**WHITE LAKE TOWNSHIP
INTER-OFFICE MEMORANDUM
COMMUNITY DEVELOPMENT DEPARTMENT**

**SUBJECT: Black Rock
Preliminary site plan approval**
Property described as parcel number 12-23-129-018 (9531 Highland Road), located south of Highland Road and east of White Banks Blvd, consisting of approximately 2.78 acres.

RE: Black Rock – Preliminary Site Plan Review – 2nd Review

RE: Black Rock
Preliminary Site Plan and Special Land Use – Review #2

STORM WATER PLAN

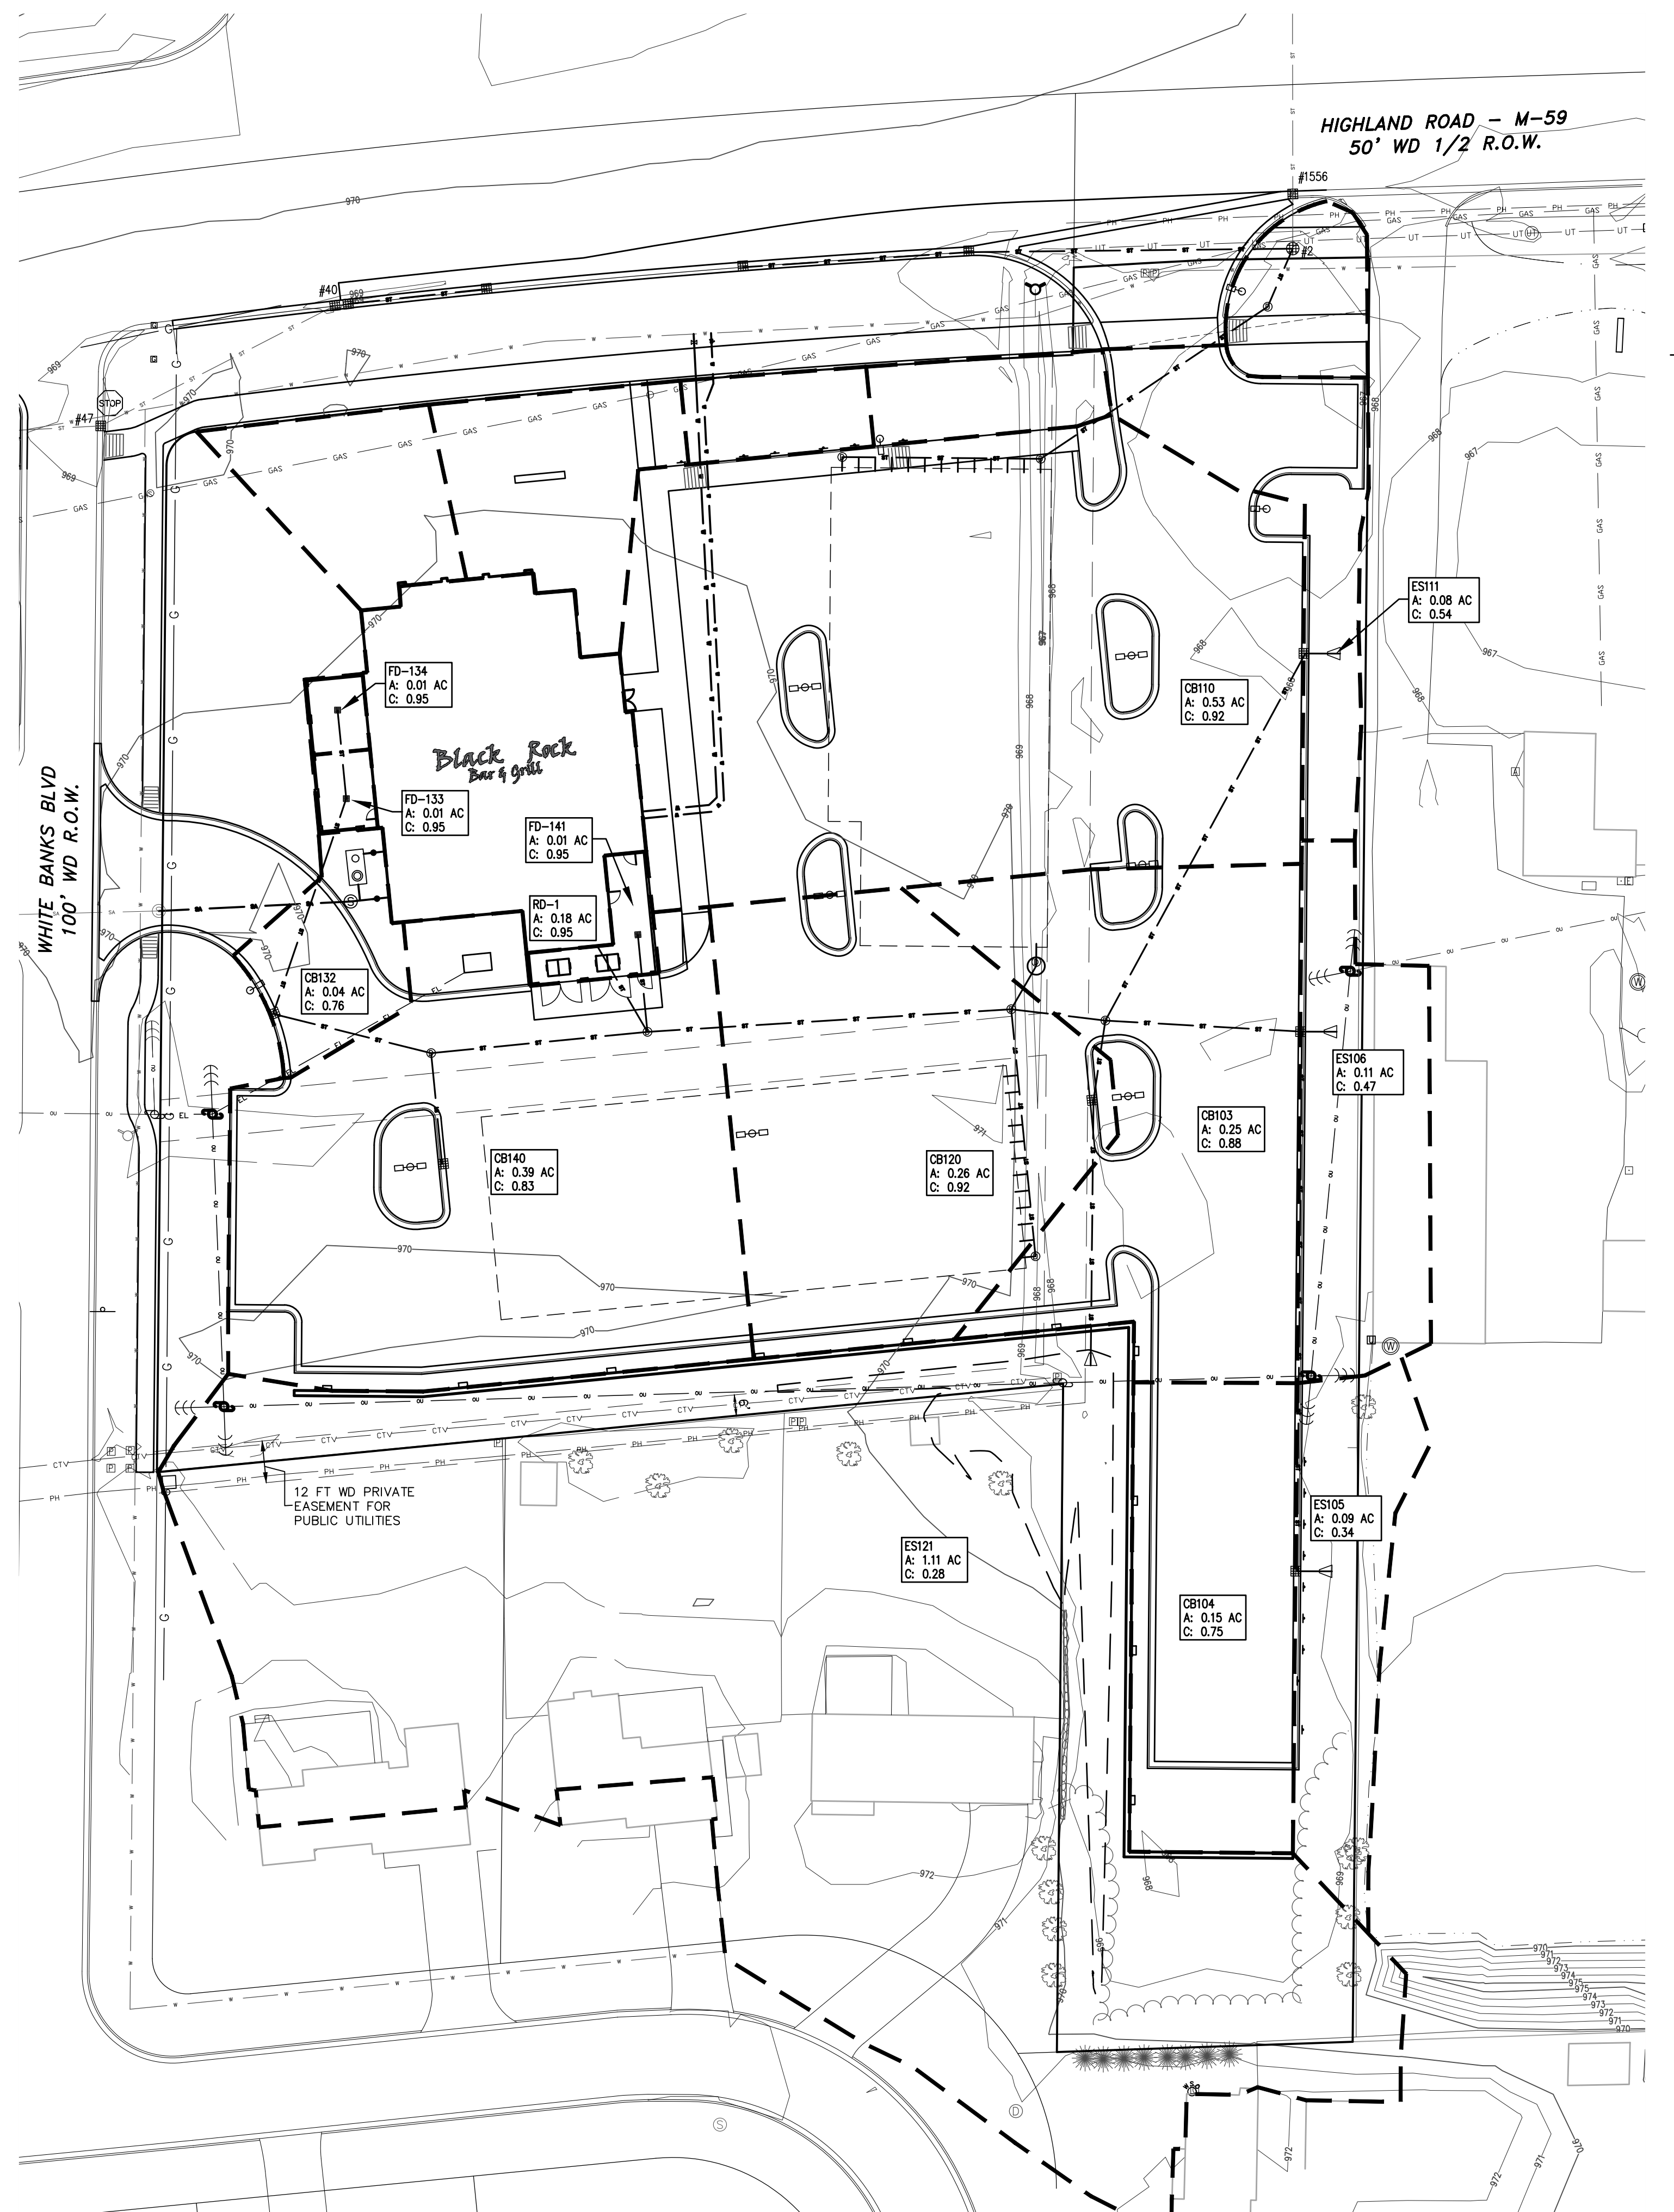
1. *Minimum 24" inlet structure depth shall be 3.5' from top of frame and cover to invert. The three inlets (CB-123, CB-141, and CB-101) are less than 3.5' deep.* **Comment remains. Design engineer indicates**
-

2. *The design engineer will need to demonstrate that the proposed storm sewer material (HDPE-S) will maintain its integrity when located under proposed pavement, otherwise use CLIV Reinforced Concrete pipe within pavement influence. Comment remains. Design engineer states that documentation relative to the proposed HDPE-S pipe material will be provided at the time of FEP submittal.*
3. *The storm pipe from FES-210 to MH-200 is not identified with length, size, material, and slope on sheet UT. Comment rescinded. Proposed pipe FES-210 to MH-200 is no longer proposed.*
4. *Indicate length of roof drains. Comment addressed.*

in 08/18/2022 response letter that the storm system has been revised to address the cover issue. This item will be further reviewed at the time of FEP submittal.

Landscape Plan
North

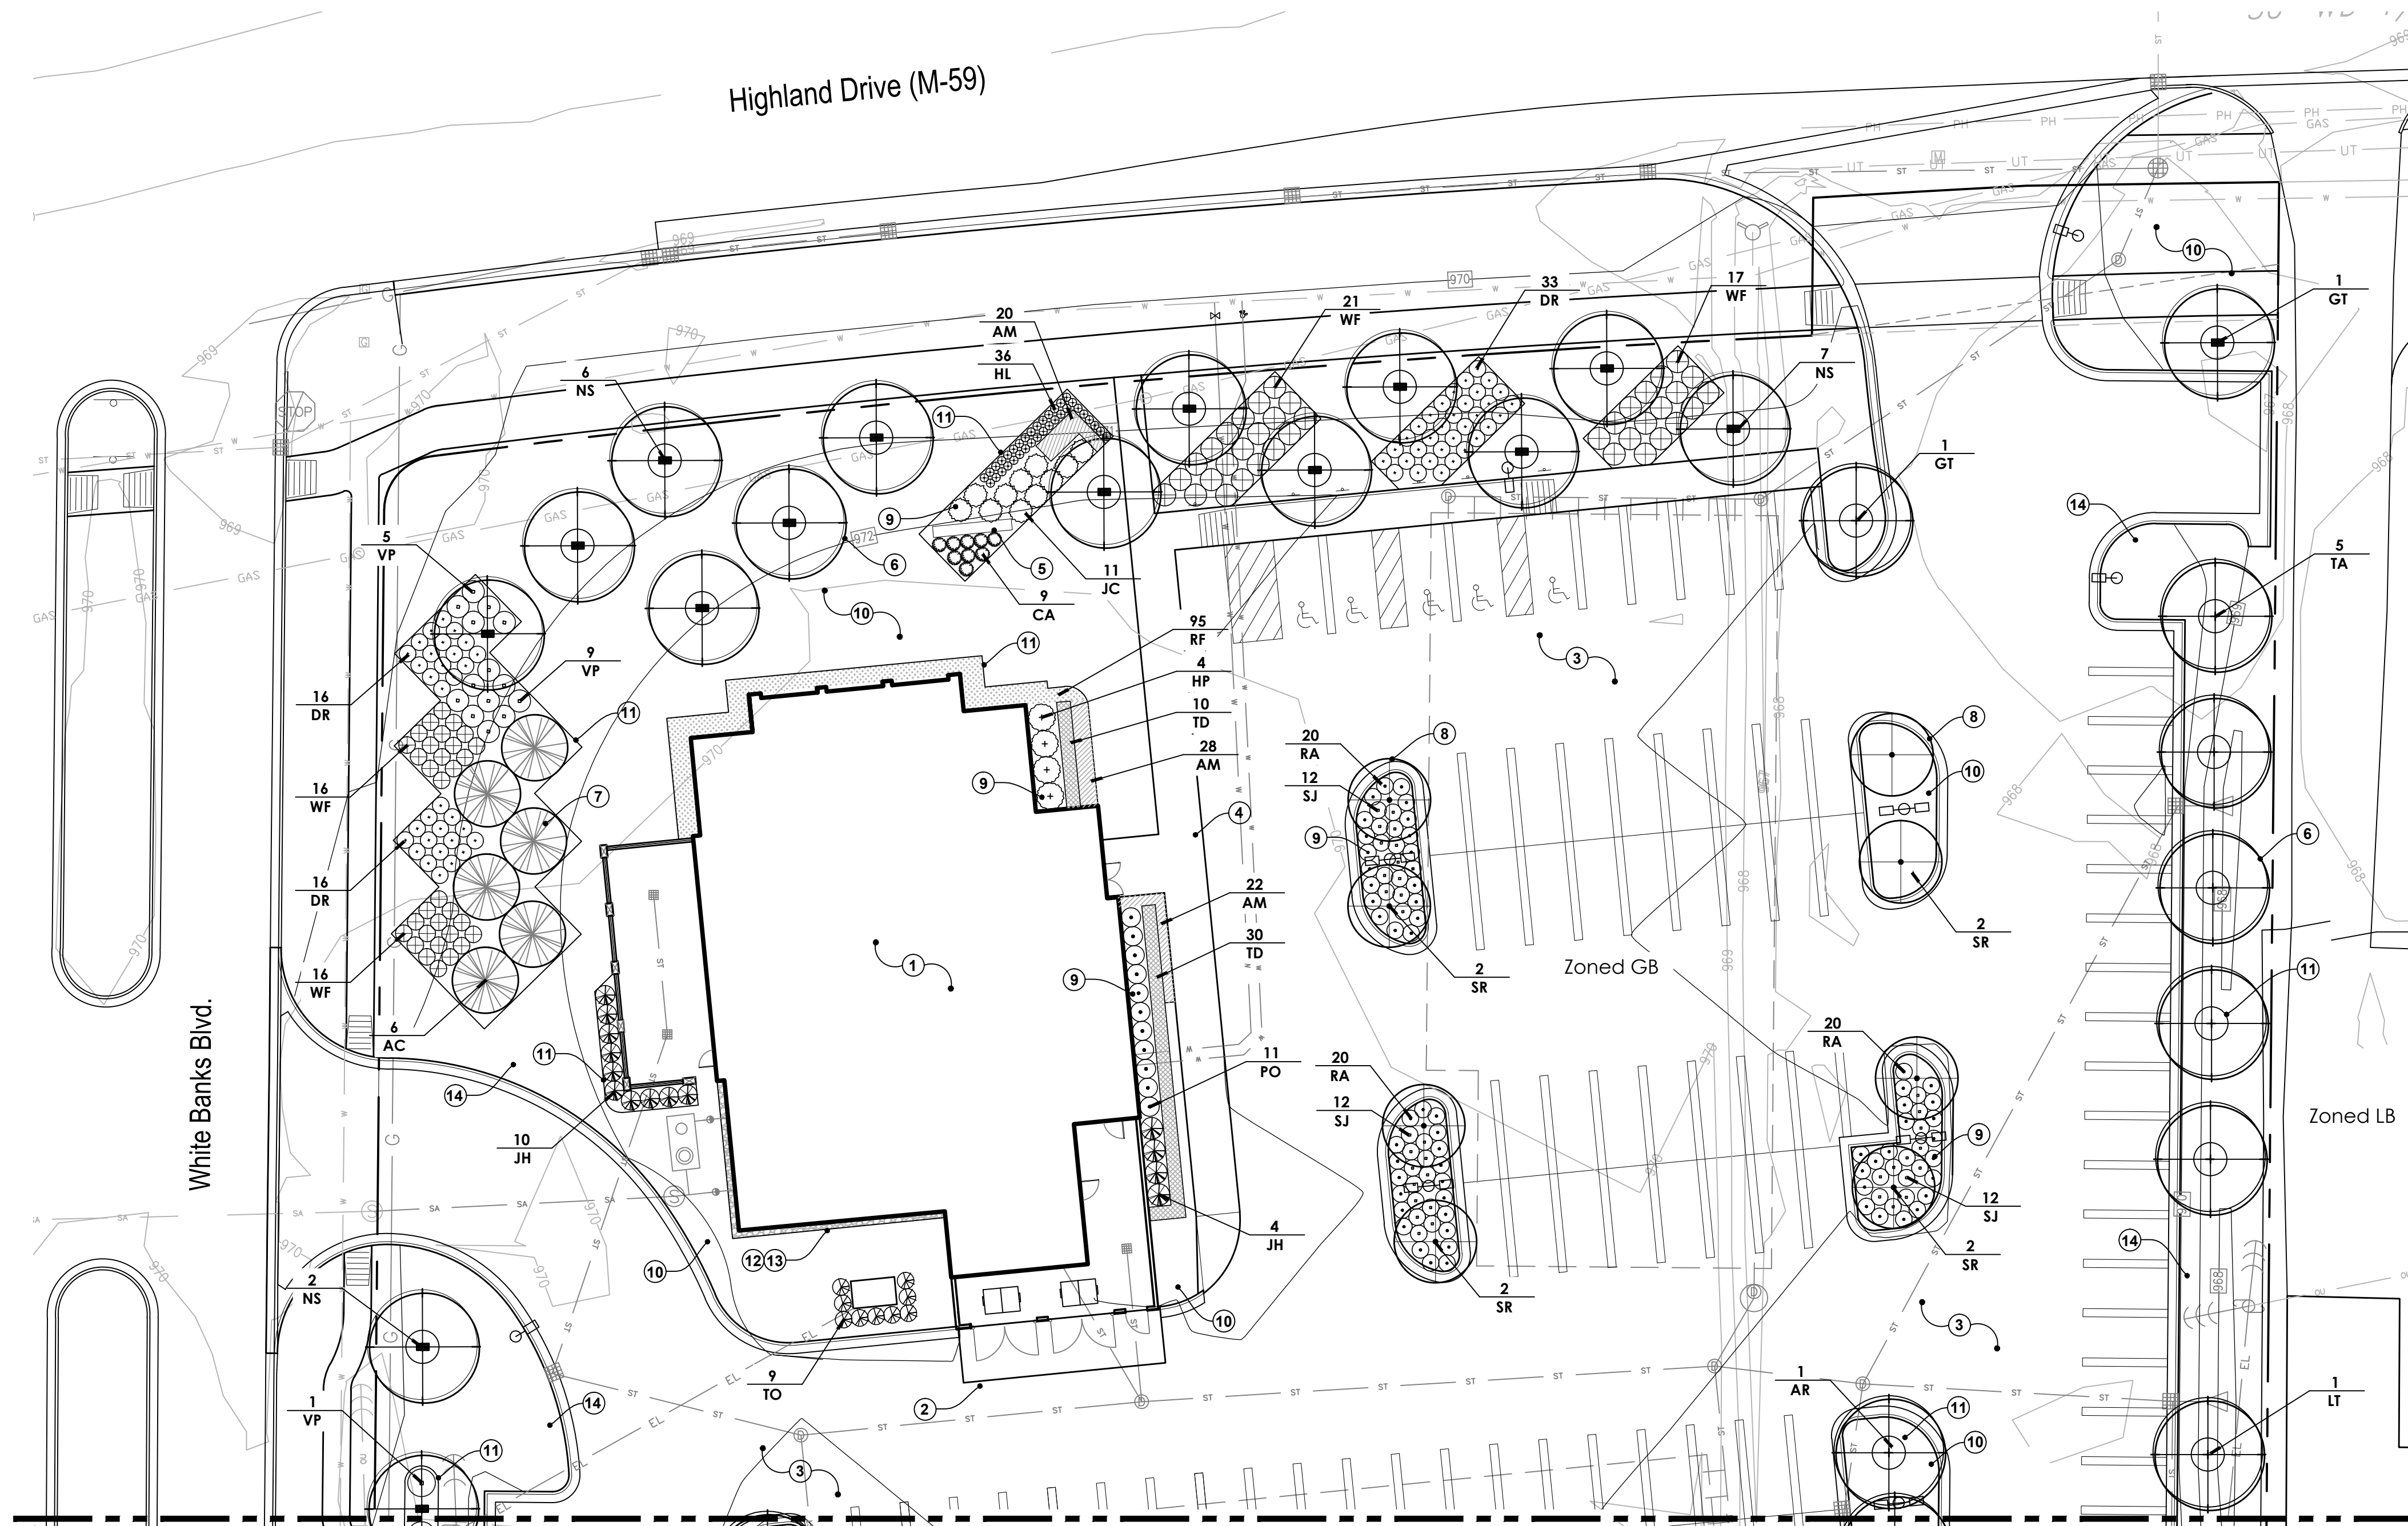
- **The screen wall along the south property line (north of 847 W. Oxhill Drive) shall be extended 10 feet westward. Revise accordingly.** (Comment addressed. The proposed screen wall has been extended to the west approximately 10 feet to align with the end of the proposed parking spaces).

- **At least six evergreen trees shall be provided generally west of the screen wall described above. The Red Oak tree in said area shall be replaced with an evergreen tree.** (Comment partially addressed. Three White Pines have been specified in the aforementioned area. In the response letter provided to the first review, the Developer's landscape architect stated six trees were unable to be provided due to the existing overhead utilities and pole. Note pine trees are prohibited in the Township; a different species of evergreen tree shall be proposed).

- **Staff does not recommend use of the proposed Grey Owl Juniper in front of the monument sign. A combination of Francee Hosta and Stella D' Oro Daylily would be more pleasing in appearance; other plantings around the monument sign may be proposed for consideration. Furthermore, the landscape bed should be located around all sides of the monument sign, with plantings provided on all sides of the sign.** (Comment partially addressed. Landscaping is now proposed on all sides of the sign. The number of Grey Owl Juniper has been reduced and additional plantings have been proposed. Staff still does not recommend use of the proposed Grew Owl Juniper in front of the monument sign).

- **The Planning Commission should note three of the parking lot landscape islands are proposed to be completely covered with Grow-Low Sumac. A different groundcover should be proposed to add diversity among plantings. Grow-Low Sumac, when not maintained, loses aesthetic appeal. Use of Grow-Low Sumac is generally not preferred. (Comment partially addressed. Additional plants have been proposed in the parking lot islands. Staff maintains use of Grow-Low Sumac is generally not preferred).**

- **No landscaping is shown in the stone beds at the north side (and northwest corner) of the building. The width of the bed shall be increased to four feet and furnished with plantings. (Comment addressed. Additional plantings have been added to the north side of the building).**

EAST ELEVATION
SCALE: 1/4" = 1'-0"

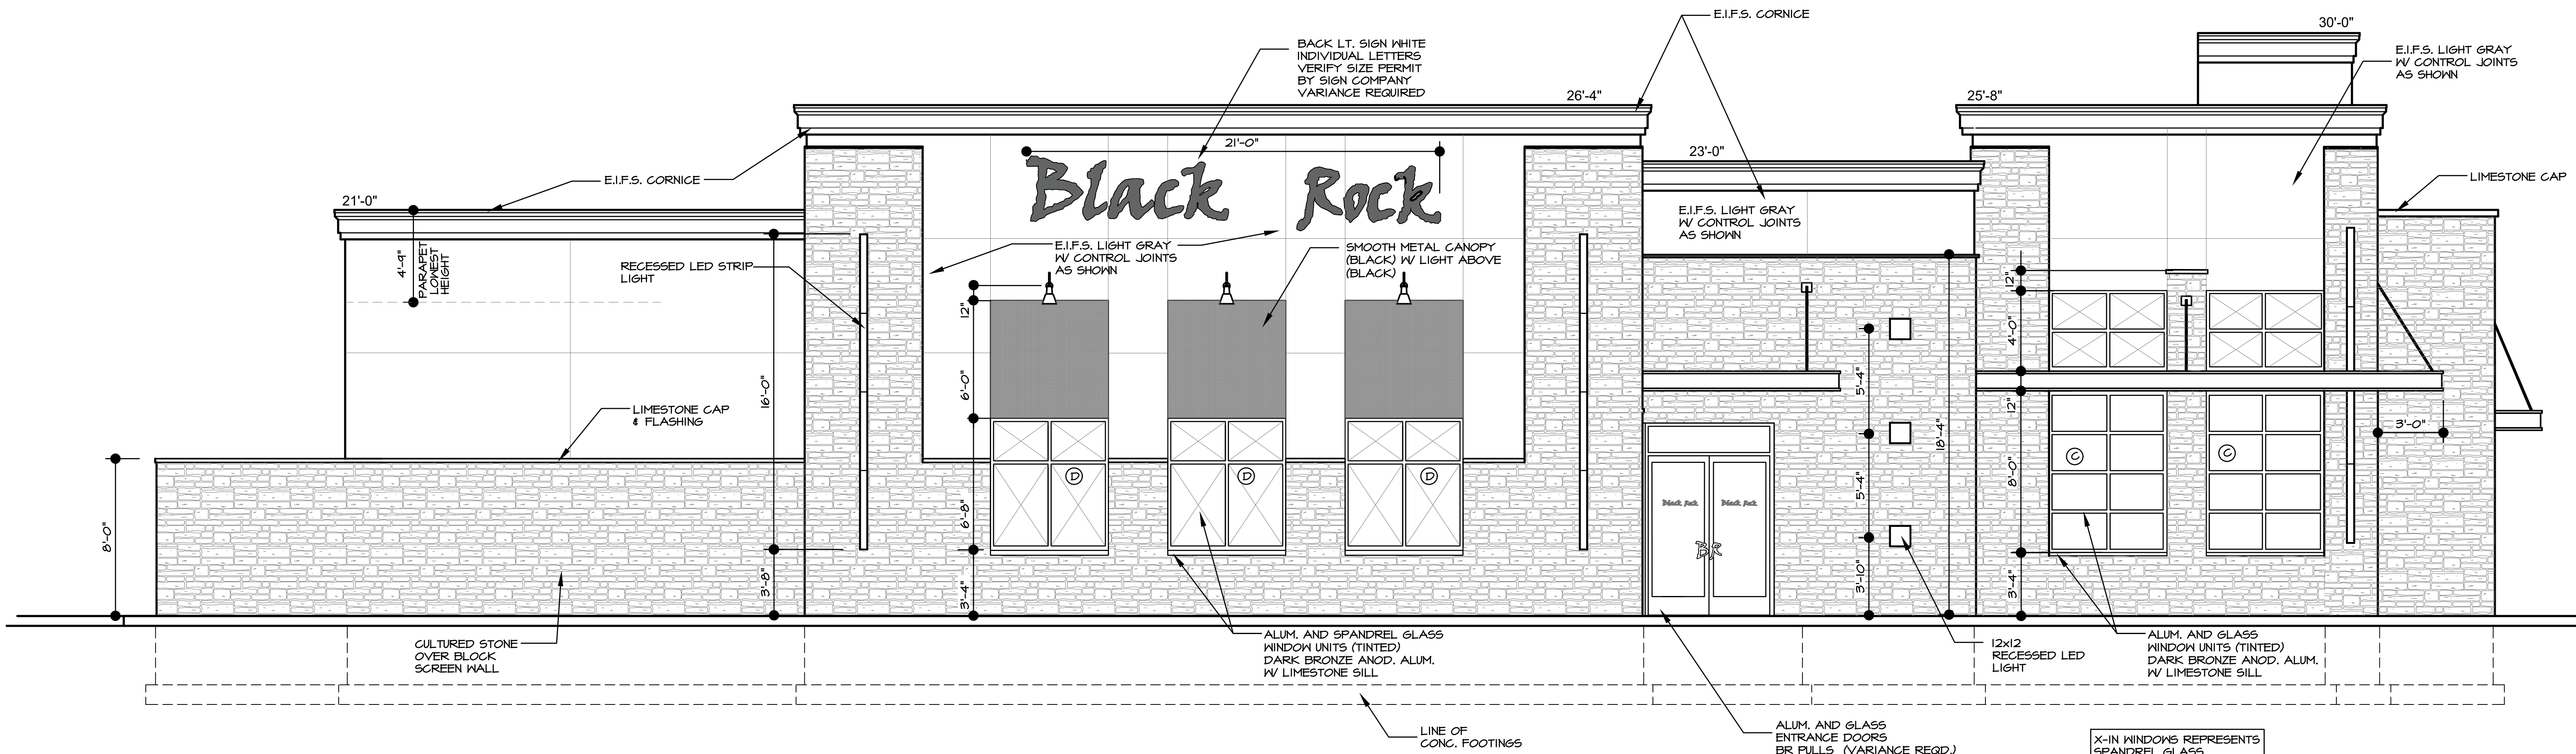
Wherever a side or rear facade is visible from a street, or if parking is located at the side or rear of a building, the facade shall be designed to create a pleasing appearance, using materials and architectural features similar to those present on the front of the building. **On the east elevation of the building, the 4’-6” section of cultured stone veneer shall be increased in height by six feet, to 10’-6”.** **The exterior elevations shall be revised accordingly at final site plan.** **(Comment addressed. East elevation cultured stone has been raised six feet to a height of 10’-6”).**

On the east elevation, the public entrance to the building contains doorhandles with the Black Rock logo (BR). **The doorhandles meet the zoning ordinance definition of a sign; therefore, a variance is required from the Zoning Board of Appeals.** (Comment outstanding; however, the Developer intends to seek a variance from the Zoning Board of Appeals).
